Road Safety Audit Designers Response for: Westfield Solar Farm

AMA Project Number: 300558

Buntingford Munches Farm, Clothall – Solar Farm Primary Access S278

Stage 1 Road Safety Audit

Problem Location Plan

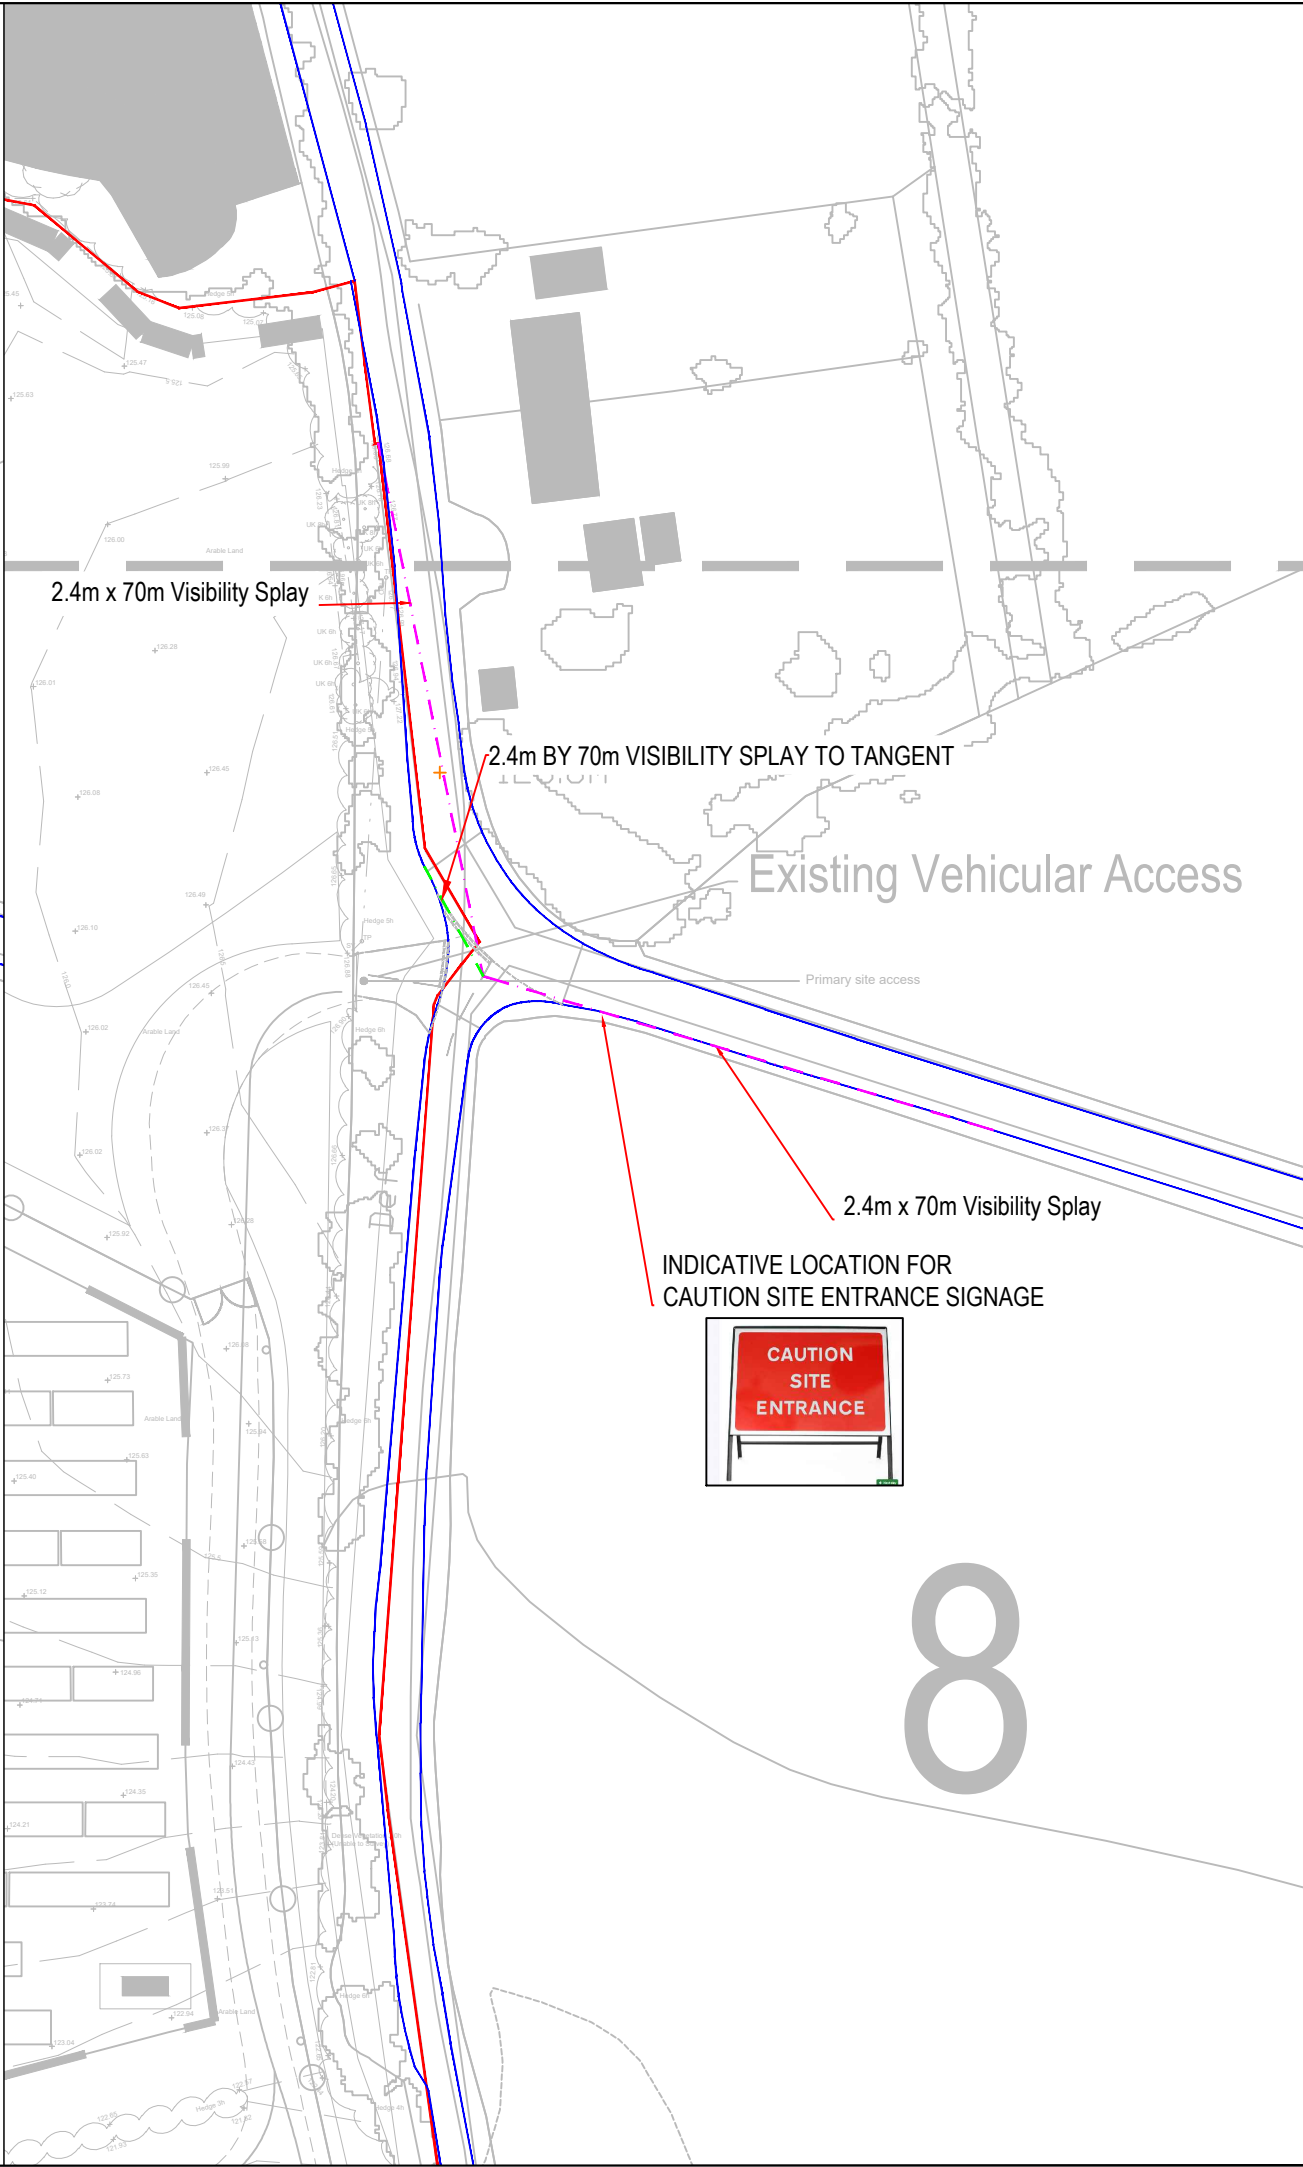
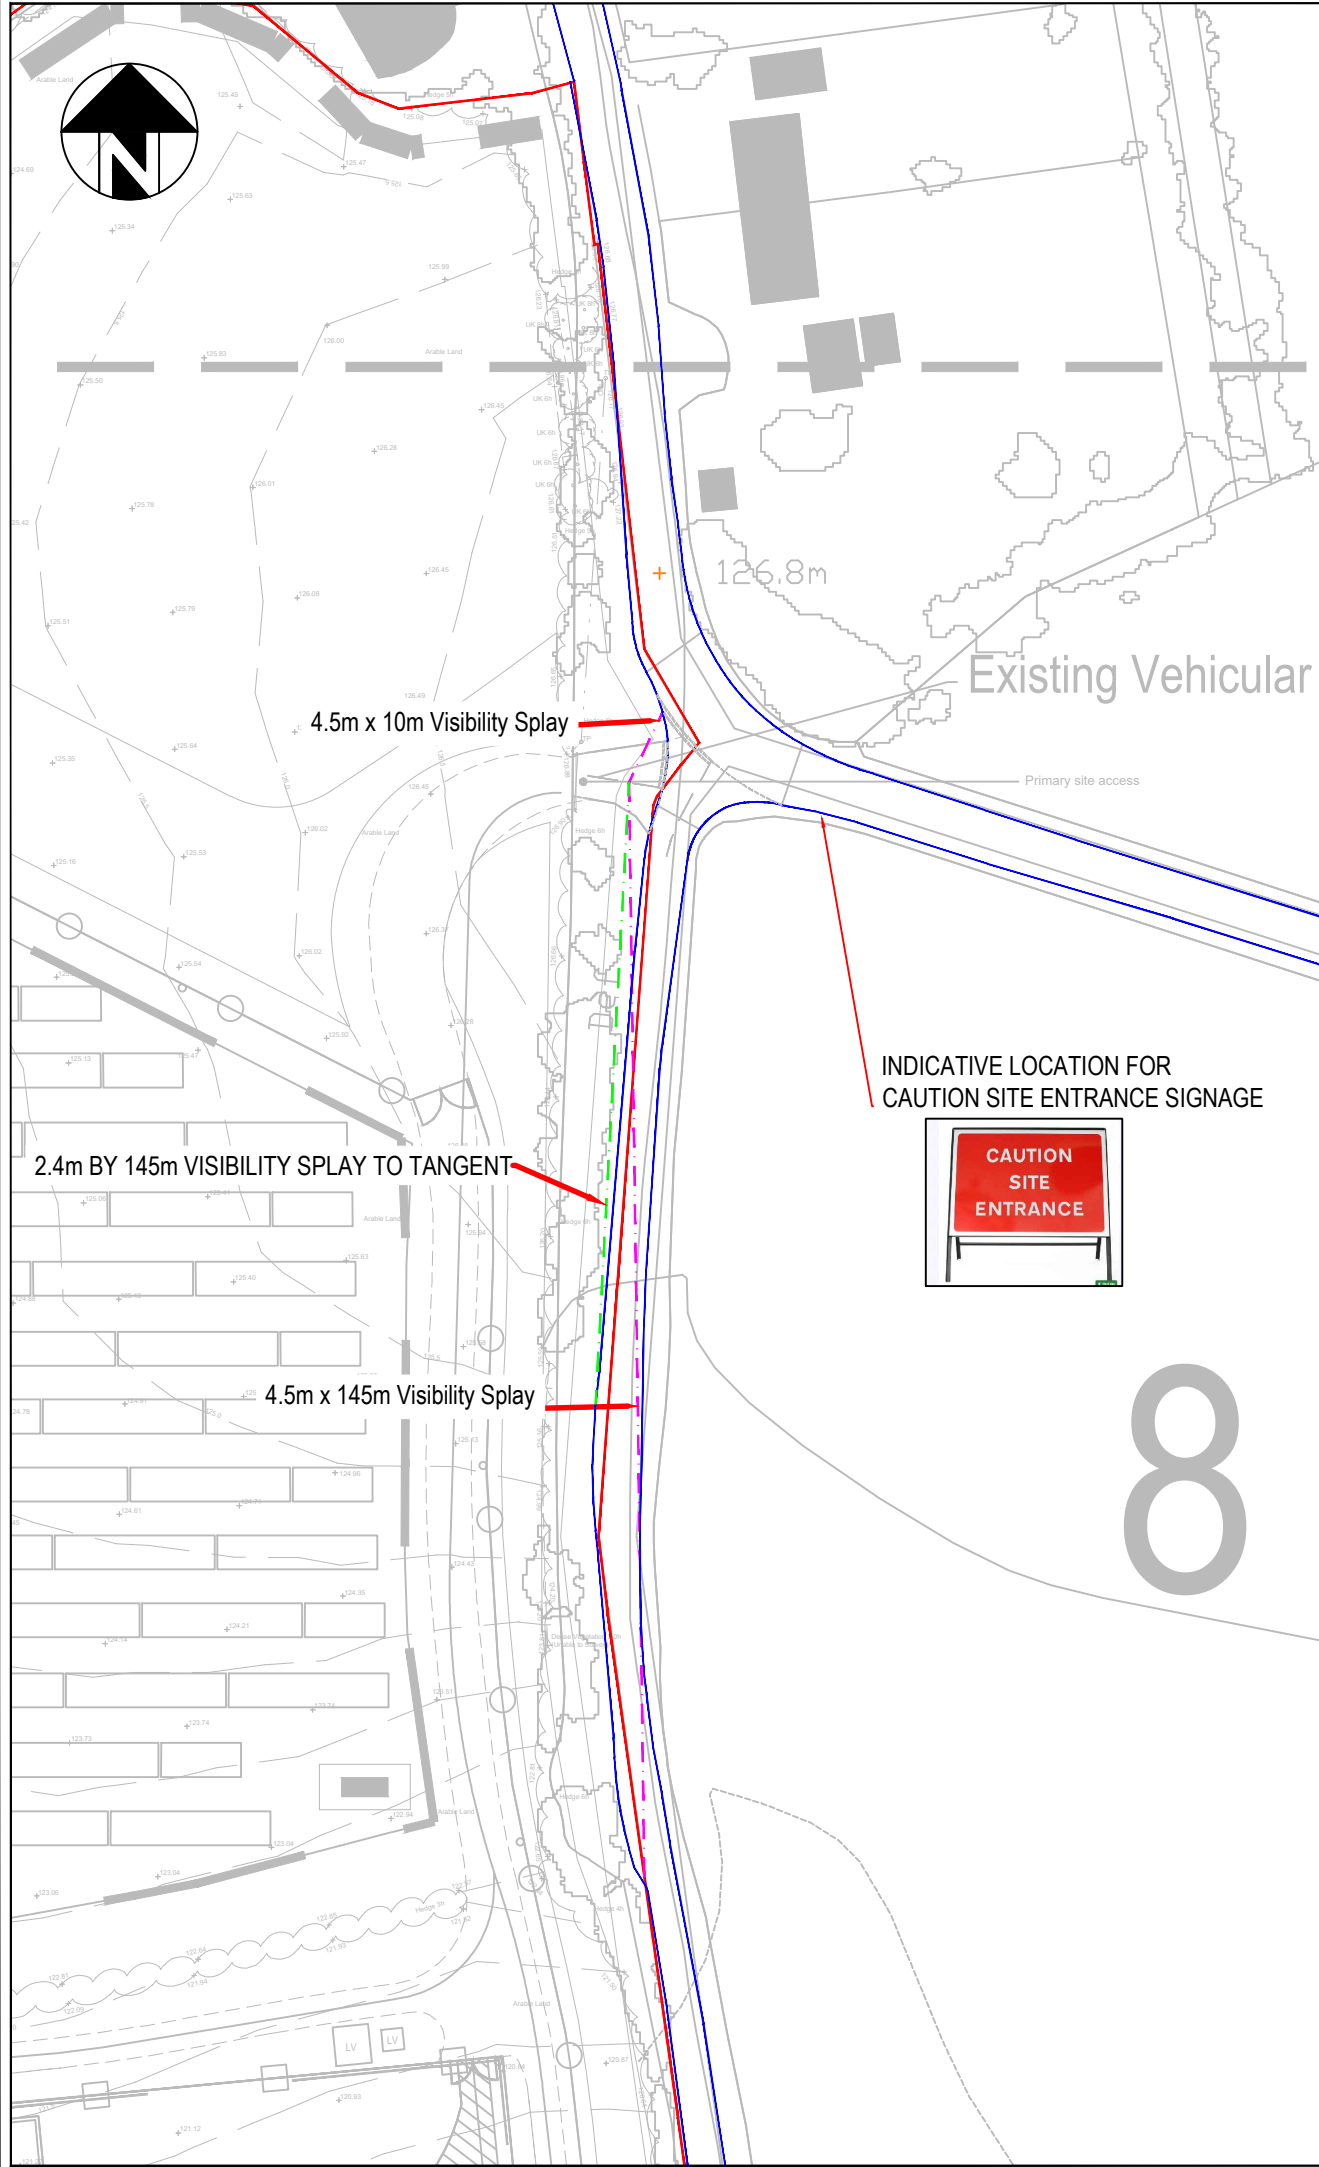
PROBLEM		1-1
Location:	Proposed primary site access	
Summary:	Risk of late braking manoeuvres resulting in shunt type collisions	
The proposed primary development assess is located in close proximity to an existing priority junction between the A507 and Cromer Heath. There are mature, high level hedgerows adjacent to the A507 and Cromer Heath which greatly reduces visibility between the two traffic flows when approaching the junction (see photos). Large vehicles travelling westbound along the A507, intending to enter the proposed development will turn left off the A507 and have very limited visibility of any vehicles travelling north along Cromer Heath. The A507 is subject to the national speed limit. Should a vehicle be approaching the junction along Cromer Heath at the same time a vehicle is turning into the site access from the A507, it could result in heavy, late braking manoeuvres due to the lack of visibility. This could then result in shunt type collisions with other traffic on the A507.

RECOMMENDATION		
Ensure that visibility is improved between vehicles on the A507 and vehicles on Cromer Heath and consider the frequency of anticipated turning movements once the site access is open. In the event of this being a high frequency on opening but diminishing over time, consider a temporary speed reduction around the junction

PROBLEM		1-2
Location:	A507 junction with Cromer Heath	
Summary:	Risk of verge overrun resulting in mud/debris being brought onto the highway	
The vehicle swept path drawings show that when an HGV is turning left off the A507, its nearside wheels are very close to the nearside verge. This area of verge is currently showing signs of vehicles overrun (see photo). There is a risk that overtime, HGVs could continue to overrun this section of highway verge when entering the site, resulting in mud and debris being brought onto the carriageway which could become a skid hazard for other road users. 		
RECOMMENDATION		
Ensure drivers entering the site do not overrun the highway verges and/or provide localised hardening of the verge

Problem 1-1

Problem 1-2

RSA Problem	RSA Recommendation	Design Organisation Response	Overseeing Organisation Response	Agreed RSA Action
1- 1 The proposed primary development assess is located in close proximity to an existing priority junction between the A507 and Cromer Heath. There are mature, high level hedgerows adjacent to the A507 and Cromer Heath which greatly reduces visibility between the two traffic flows when approaching the junction (see photos at Appendix A). Large vehicles travelling westbound along the A507, intending to enter the proposed development will turn	Ensure that visibility is improved between vehicles on the A507 and vehicles on Cromer Heath and consider the frequency of anticipated turning movements once the site access is open. In the event of this being a high frequency on opening but diminishing over time, consider a temporary speed reduction around the junction	As set out within the Transport Statement the busiest delivery period at the site occurs from months 6-8 with four HGV trips an hour. This results in one HGV movement every 15 minutes which is not considered to be a high frequency movement. When the full 18-month period of construction is considered, vehicle numbers are lower with an average of 2 HGV trips per hour. This results in one HGV movement every 30 minutes. When the site is open, the number of vehicle movements will be minimal. Maintenance vehicles are expected to visit the Site occasionally, typically no more than once per week. The A507 incorporates a sharp bend at this location, with highway signage located to the east of the bend recommending a speed of 20mph for vehicles travelling through the section, as illustrated below.

RSA Problem	RSA Recommendation	Design Organisation Response	Overseeing Organisation Response	Agreed RSA Action
left off the A507 and have very limited visibility of any vehicles travelling north along Cromer Heath. The A507 is subject to the national speed limit. Should a vehicle be approaching the junction along Cromer Heath at the same time a vehicle is turning into the site access from the A507, it could result in heavy, late braking manoeuvres due to the lack of visibility. This could then result in shunt type collisions with other traffic on the A507.		 The existing hedgerow will be cut back and maintained to the back of the adopted highway as shown above to ensure the visibility is not obstructed during the construction and operation of the site. As set out within the CTMP, signage will be located in the vicinity of the site access on the A507 during the construction period to make other drivers aware of the construction site entrance. The site access drawing has been updated to include signage to make drivers aware of the site entrance as shown in Appendix B. To the east of the site, the straight alignment of the A507 provides adequate forward visibility, enabling approaching drivers to clearly observe construction vehicles slowing in the vicinity of the A507/Cromer Heath junction and adjust their speed accordingly. It is also proposed to provide a 180 elliptical mirror at the northern side of the site access at the junction of Cromer Heath and the A507 sited at the optimal location to maximise visibility to allow vehicles travelling north on Cromer Heath to have improved visibility of construction vehicles on the A507. Construction vehicles on the A507 will also be able to have improved visibility of vehicles on Cromer Heath and give way as appropriate.

1-2 The vehicle swept path drawings show that when an HGV is	Ensure drivers entering the site do not overrun the highway verges	As demonstrated by the vehicle swept path analysis submitted previously during the planning application and along with the RSA brief, HGVs turning left from the A507 into the site access are able to complete the manoeuvre

RSA Problem	RSA Recommendation	Design Organisation Response	Overseeing Organisation Response	Agreed RSA Action
turning left off the A507, its nearside wheels are very close to the nearside verge. This area of verge is currently showing signs of vehicles overrun (see photo at Appendix A). There is a risk that overtime, HGVs could continue to overrun this section of highway verge when entering the site, resulting in mud and debris being brought onto the carriageway which could become a skid hazard for other road users.	and/or provide localised hardening of the verge	without overrunning the adjacent verge. Any existing evidence of verge overrun is therefore considered to reflect current vehicle movements at this location, including those associated with larger agricultural vehicles. Delivery drivers accessing the site will be briefed on the requirement to undertake this manoeuvre with due care and attention, ensuring that the verge is not overrun when turning from the A507 into the site. Furthermore, as set out within the Construction Traffic Management Plan (CTMP), all contractors and sub-contractors will be required to implement appropriate measures to control and minimise the generation and deposition of mud and dust associated with construction activities on the site. Should any mud and debris transgress onto the highway, warning signs will be erected to inform road users and a road sweeper employed immediately to clean up the road surface.
